DATE: December 6, 1996
TO: Closure Committee
FROM: Darcy Congo
SUBJECT: A few Richland Center sites

FILE REF:Richland Center

This group of sites with commingling issues and plumes needs a sense of direction. One of them is requesting closure. The open sites are:

FIGURE A

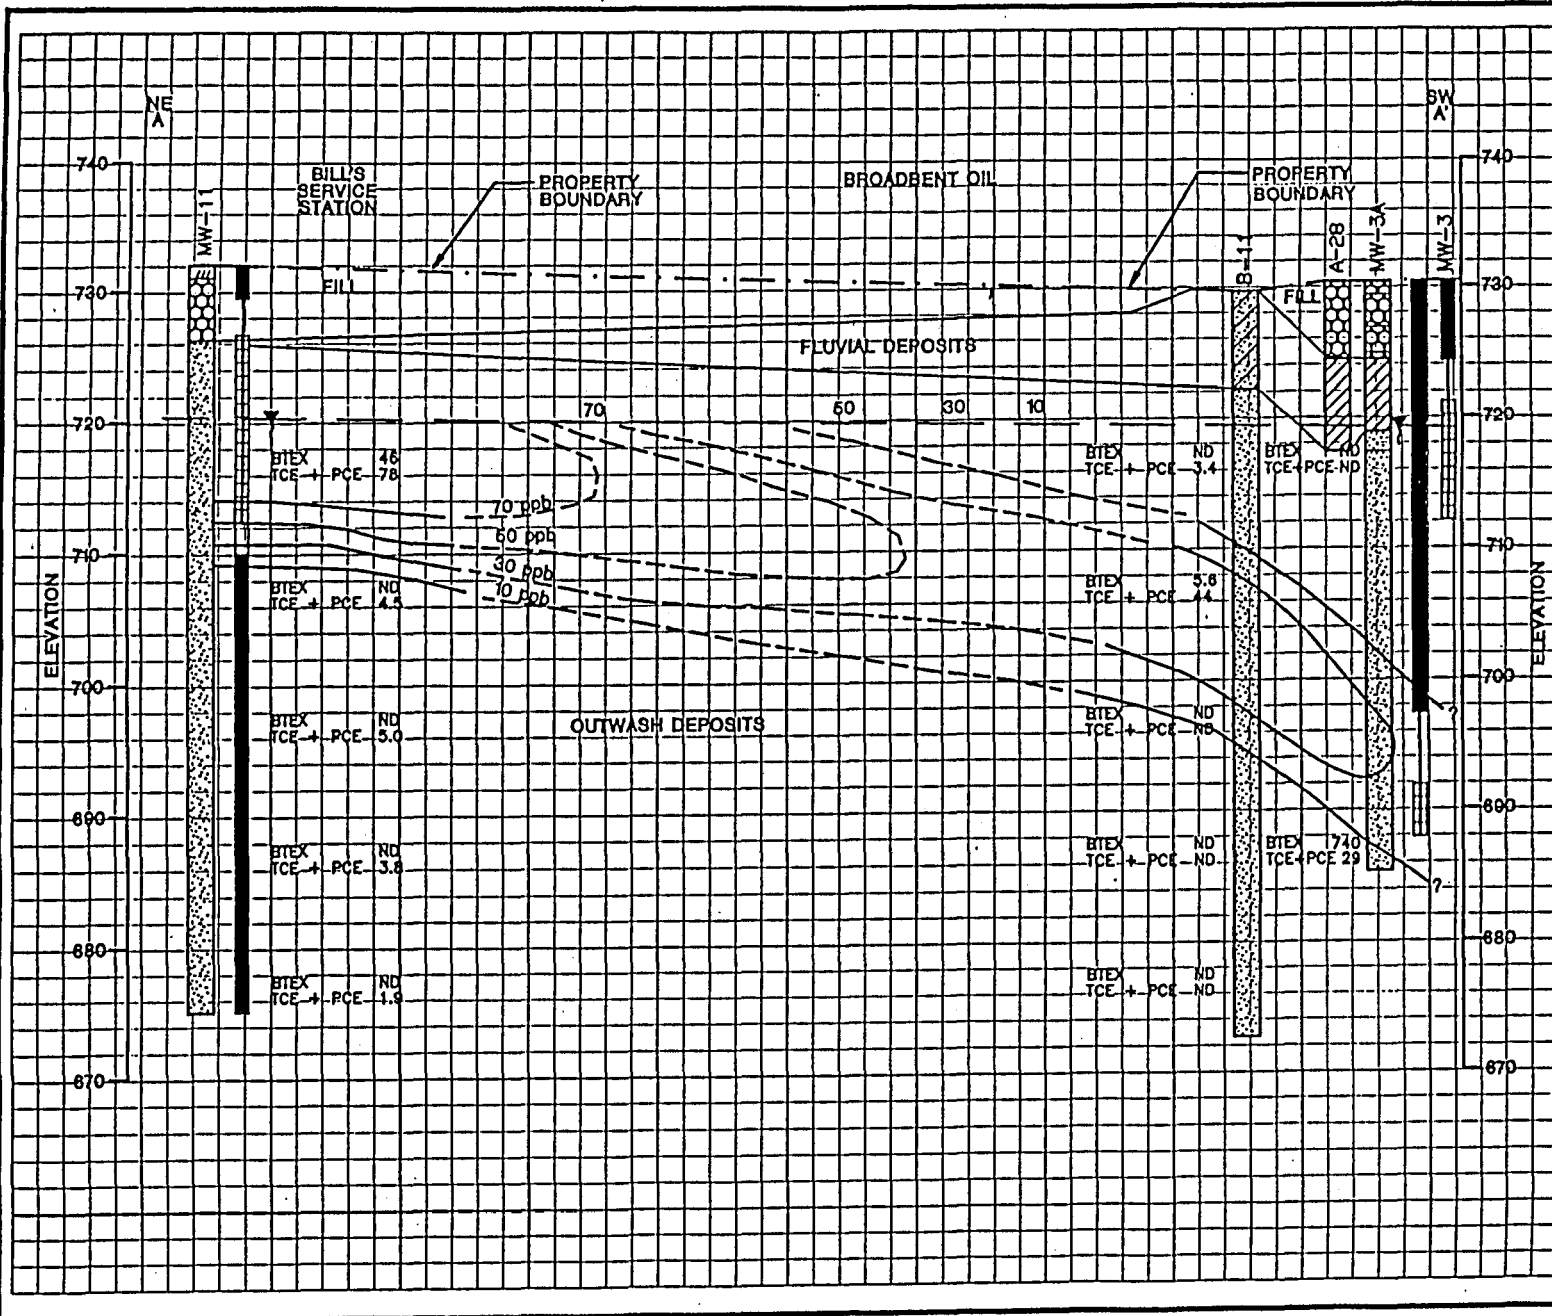
Groundwater flow is generally southwest. An investigation at the Daul Industries site closed in 1992 showed groundwater flow northeast. Those wells were since abandoned, so it is not clear what was going on. However, at this point everyone seems to agree flow is southwest. A cross section done by RMT shows a downward gradient. See figure A.

Chlorinateds show up in DOT wells MW1, MW2, MW3A (screened deep, 37-42 ft), and MW-11. It is also seen in Broadbent wells MW1 and MW5. It shows up in Spur wells MW2, MW3, MW4, and MW5. Concentrations are higher upgradient, though DOT well MW11 is not very hot compared to some of the Spur wells. See attached monitoring data.
